ITEM: 6.5	COMMITTEE OF ADJUSTMENT REPORT SUMMARY MINOR VARIANCE APPLICATION FILE NUMBER A020/23 98 PANORAMA CRESCENT, WOODBRIDGE
------------------	---

**COMMITTEE OF ADJUSTMENT REPORT
MINOR VARIANCE APPLICATION
A020/23
98 PANORAMA CRESCENT, WOODBRIDGE**

TITLE:
**GRADING AND
POOL PLAN**

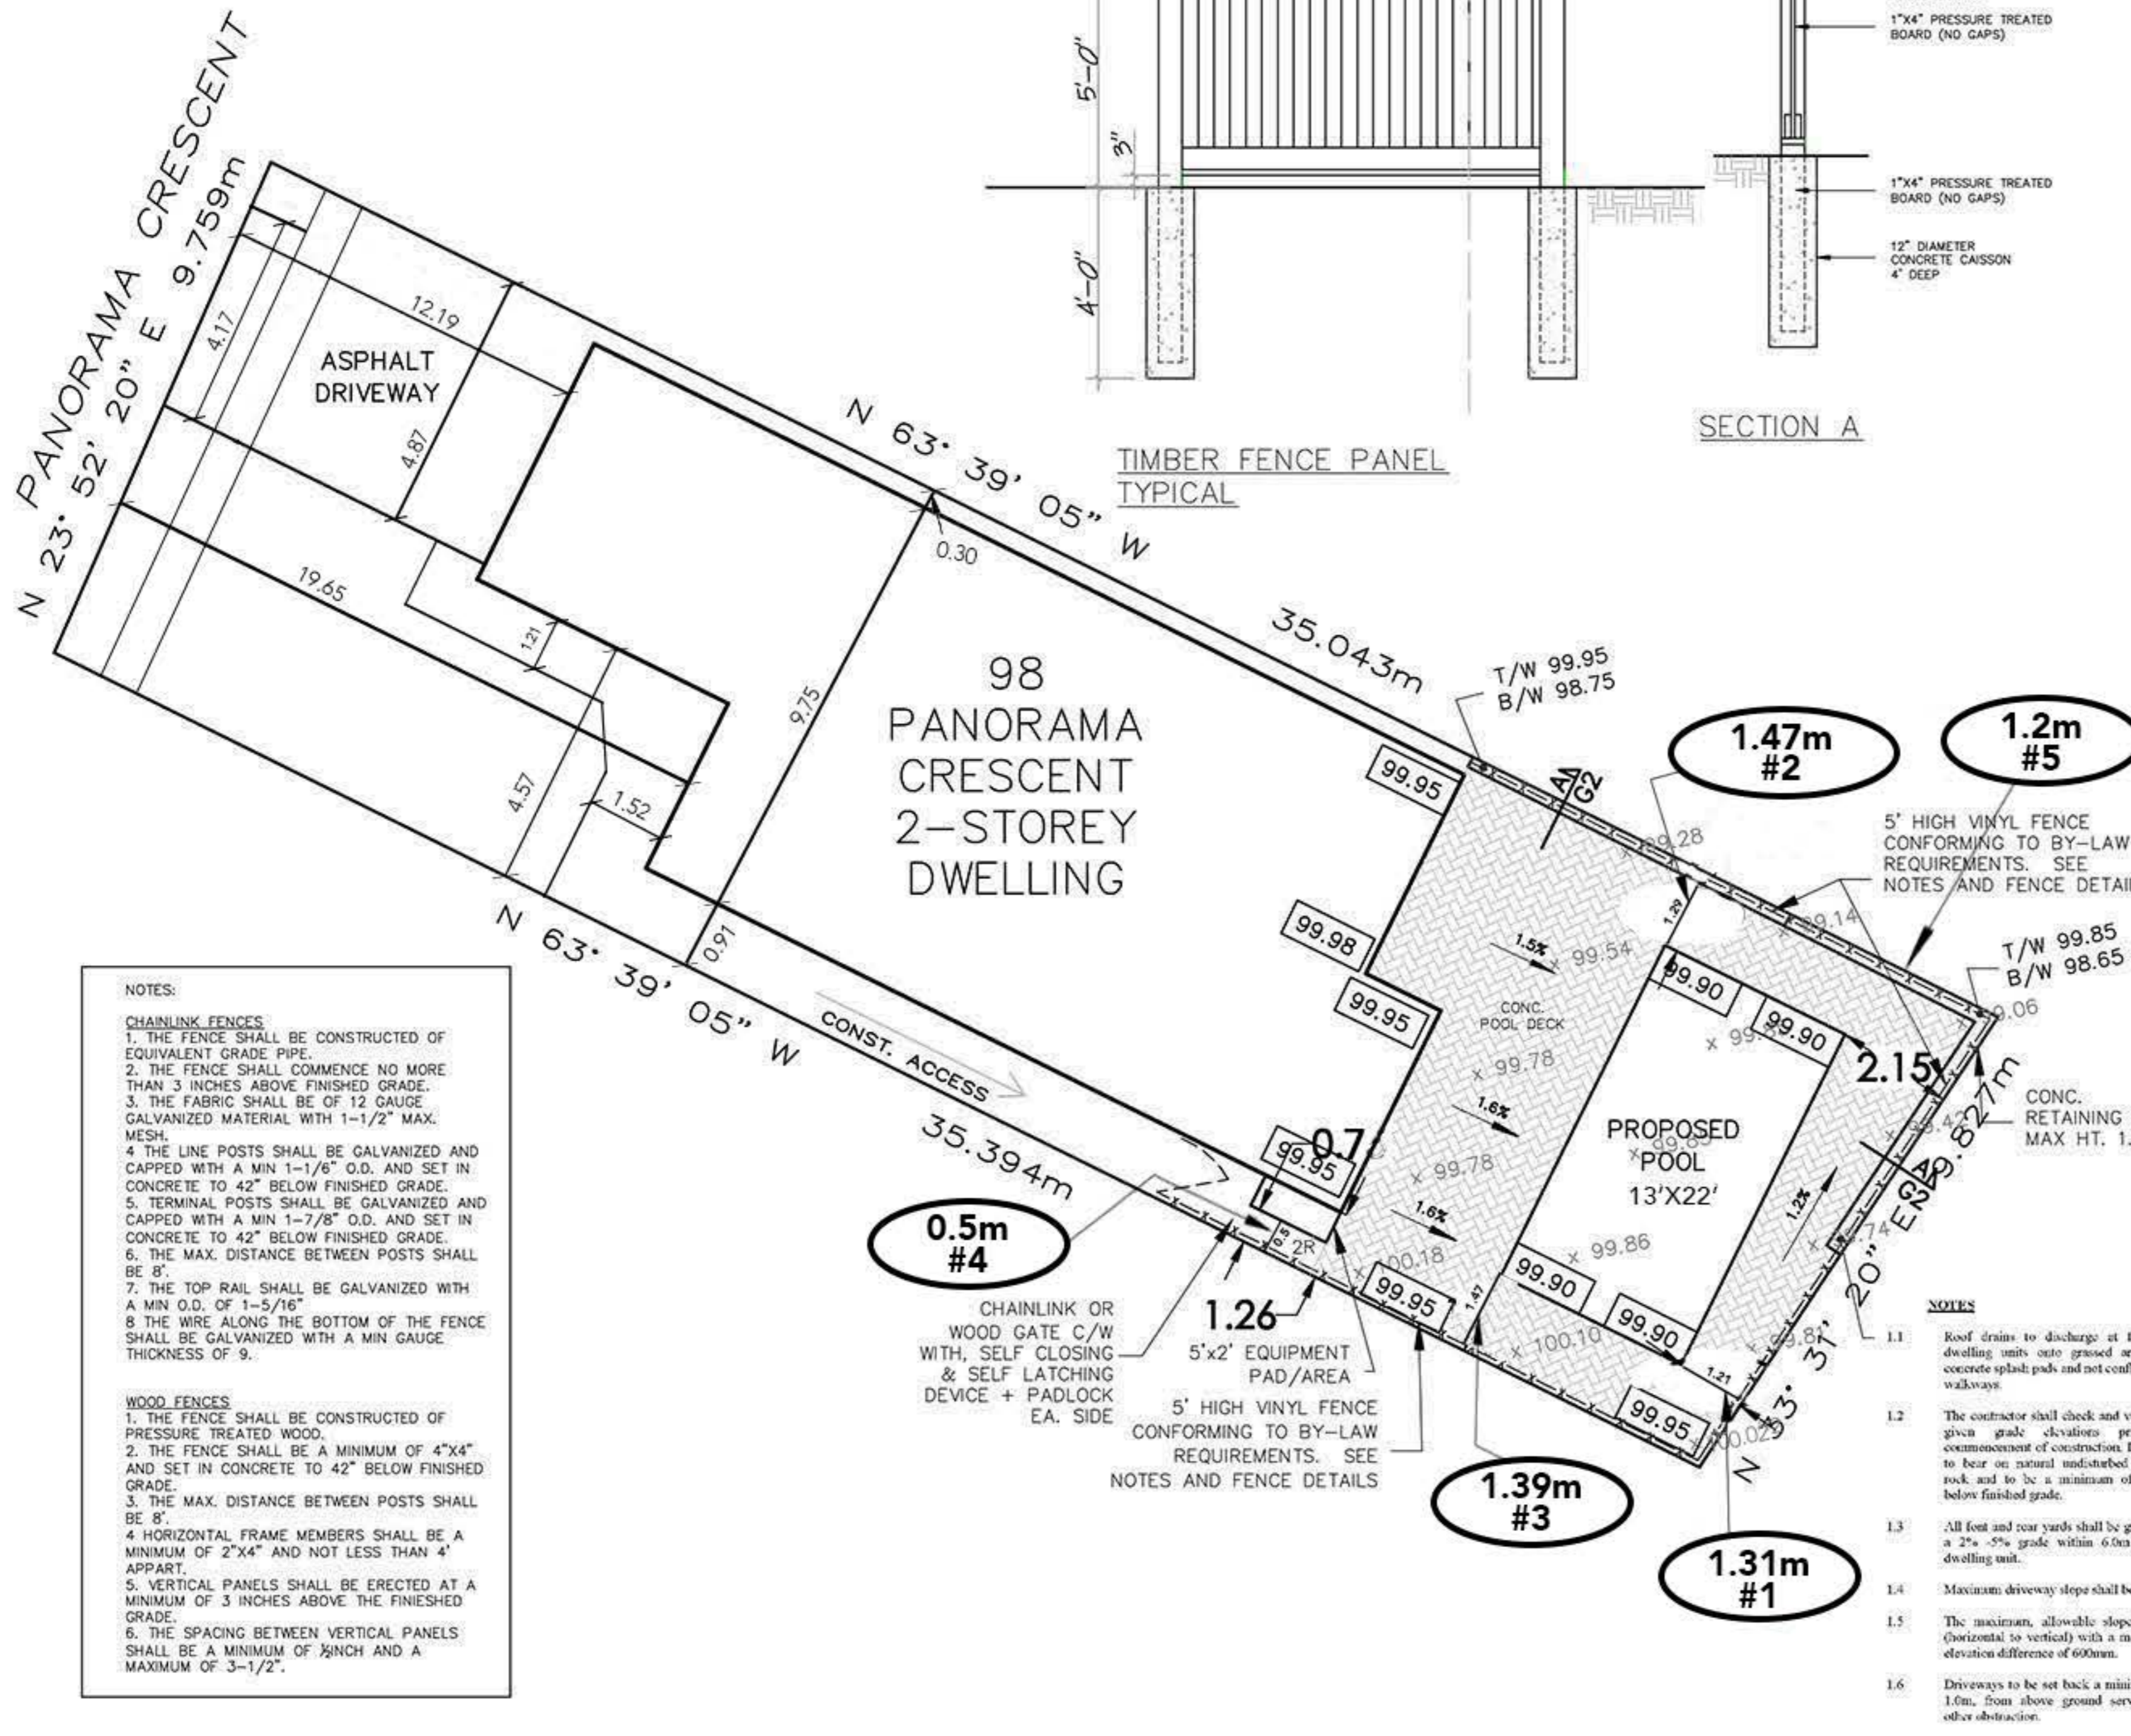
The property owner has installed a French drain system along the northeast side yard property line to prevent the retaining wall from being overwhelmed by excess water flow. The drain will outlet to an existing rear yard drainage swale and be transferred to the City's stormwater management network.

The existing retaining wall design has been reviewed and stamped by a Professional Engineer. Plans were received in February of 2023.

inspection found the following setbacks for the pool:

north side setback (interior yard) 1.47m

south side setback (interior) 1.29m

rear setback 1.21m

inspection found the following setbacks for the equipment

pipes - between 0.2m-0.6m

equipment 0.3m

there is also a retaining wall on the property that Engineering is dealing with - it will need zoning review to ensure compliance

The Development Engineering (DE) Department does not object to the variance application A020/23.
